**World Forum for Harmonization of Vehicle Regulations****Working Party on Passive Safety Provisions****Sixty-ninth session**

**UN Regulation No. 22 (Protective helmets)****Proposal for Supplement 1 to the 06 series of amendments to  
UN Regulation No. 22 (Protective helmets)****Submitted by the experts from Italy and Spain\***

### Example of the arrangement of the approval mark for a universal accessory

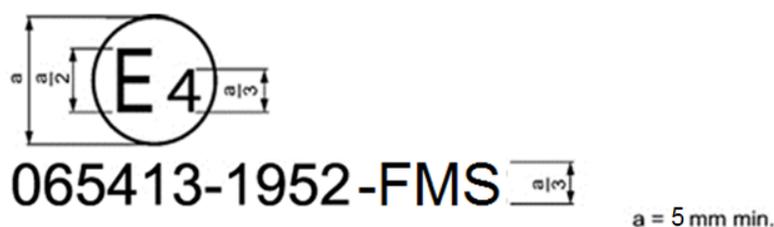
*Insert a new Annex 2C, to read:*

Due to space restrictions, the approval number could be placed on the side of the accessory facing to the helmet provided that the accessory will have a support plate and that can be easily detachable without any tool for checking.

### Example of the arrangement of the approval mark for a specific accessory

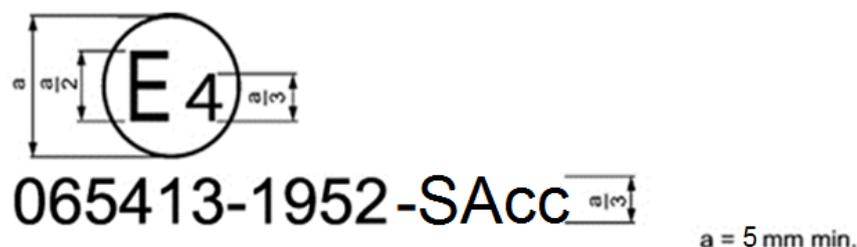
The above approval mark affixed to a specific accessory shows that the specific accessory type concerned has been approved in the Netherlands (E 4) under approval number 065413. The approval number shows that approval was granted

"Figure 1d

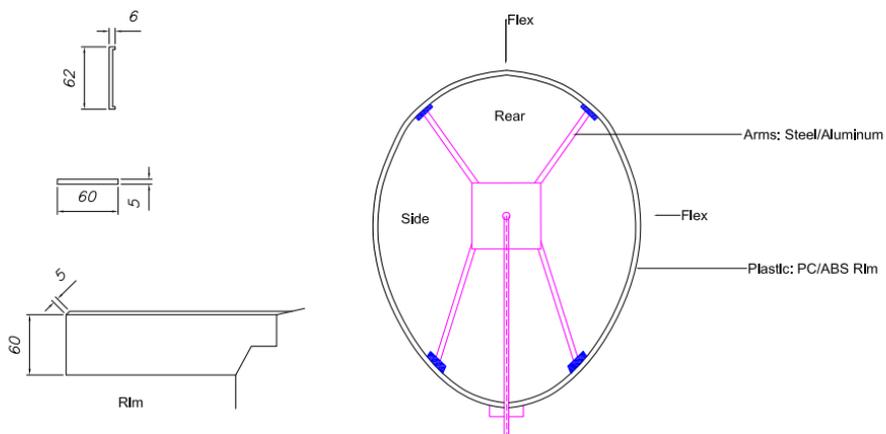
Annex 8, insert new figure 1d, to read:

**Example of a helmet simulator for accessories projections and surface friction (method B)**

**Simulator and characteristics must be detail defined."**

Figure 1

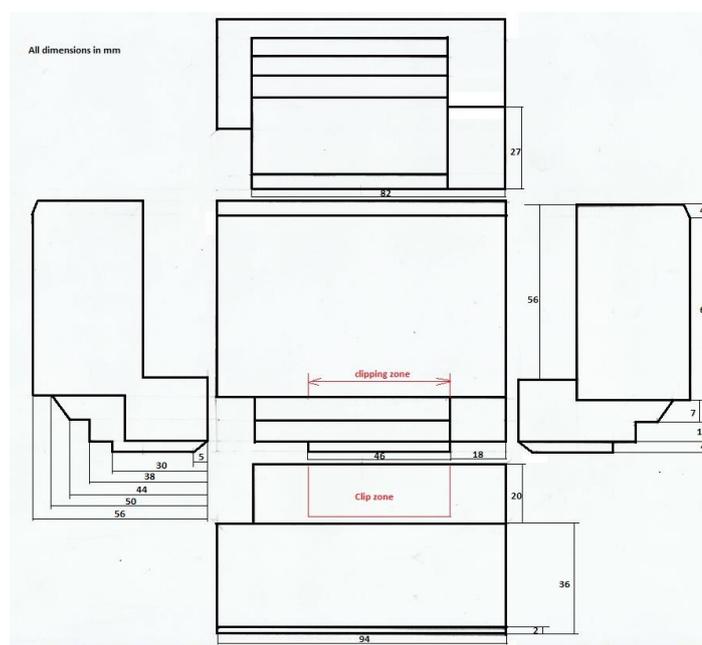
Accessories must fit in the following fixtures dimensions:

Fixture for left front- side mounting (for right side mounting apply symmetry)

VOLUME: 279,432 mm<sup>3</sup>

Figure 2

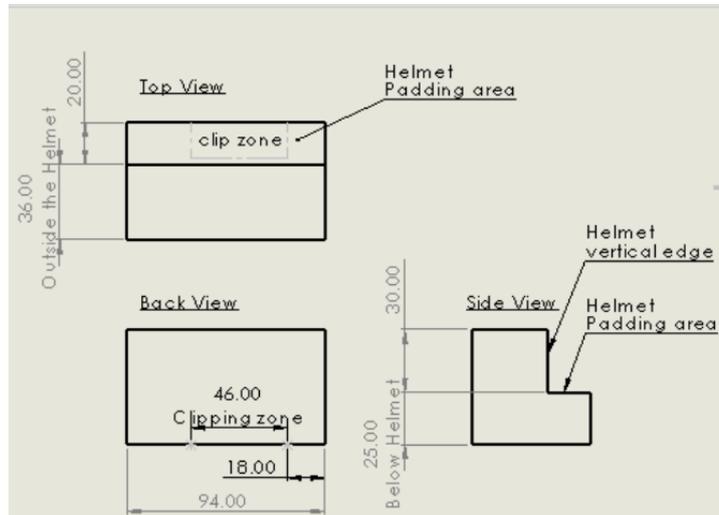
1.2. For side mounting accessories

Fixture for left side mounting (for right side mounting apply symmetry)

VOLUME: 233,120 mm<sup>3</sup>

Figure 3

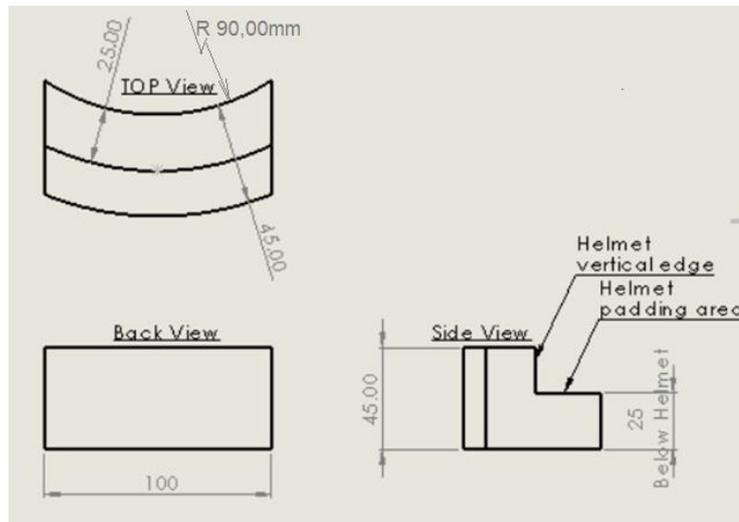
1.3. For rear mounting accessories

The rear mounting clamping solution offered by the accessories manufacturers will not invade the impact affected area.

VOLUME: 157,957 mm<sup>3</sup>
